MFN 08-251

Subject: **Response to Portion of NRC Request for Additional Information Letter Nos. 129 and 140 Related to ESBWR Design Certification Application - Auxiliary Systems - RAI Numbers 9.5-65, 9.5-67, 9.5-68 (NRC Letter No. 129), and 9.5-70 (NRC Letter No. 140)**

**Response to Portion of NRC Request for
Additional Information Letter Nos. 129 and 140
Related to ESBWR Design Certification Application**

**RAI Numbers 9.5-65, 9.5-67, 9.5-68 (NRC Letter No.
129) and 9.5-70 (NRC Letter No. 140)**

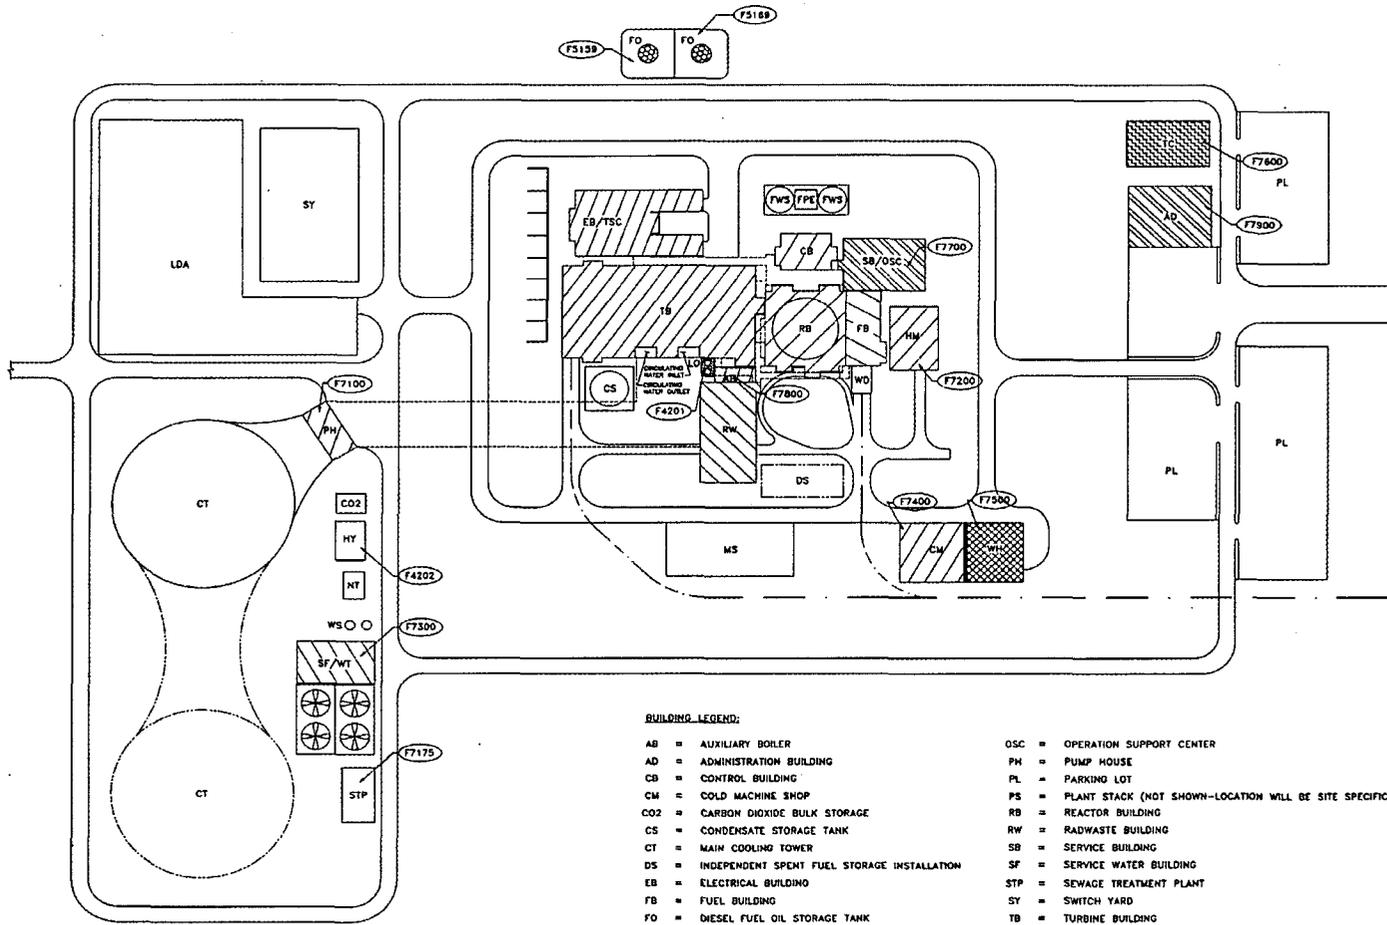
DCD Tier 2, Revision 4, Figure 9A.2-33 identifies the fire pump enclosure as fire area F7170, whereas Table 9A.5-7 identifies the fire pump enclosure as fire area F8250 for electric fire pump A and fire area F8260 for diesel fire pump B. The DCD should be revised to provide consistent numbering for the fire pump fire areas. Figure 9A.2-33 also indicates a Note 5 near the transformers, but there are only three (3) notes in the figure legend, and they are numbered sequentially from 1 to 3.

DCD Tier 2 Appendix 9A, Figure 9A.2-33, is revised in Revision 5 to delete fire area designator F7170 since there are multiple fire areas for equipment in the Fire Pump Enclosure (FPE) and it is not practical to designate several fire areas for this building on this Figure. Note 5 near the transformer area was undefined and therefore is removed in Revision 5 of DCD Tier 2 Appendix 9A, Figure 9A.2-33. There was no note 4 on DCD Revision 4.

Fire area designator F7170 and Note 5 are deleted from Figure 9A.2-33 of DCD Tier 2 Appendix 9A in Revision 5 as noted in attached mark-up.
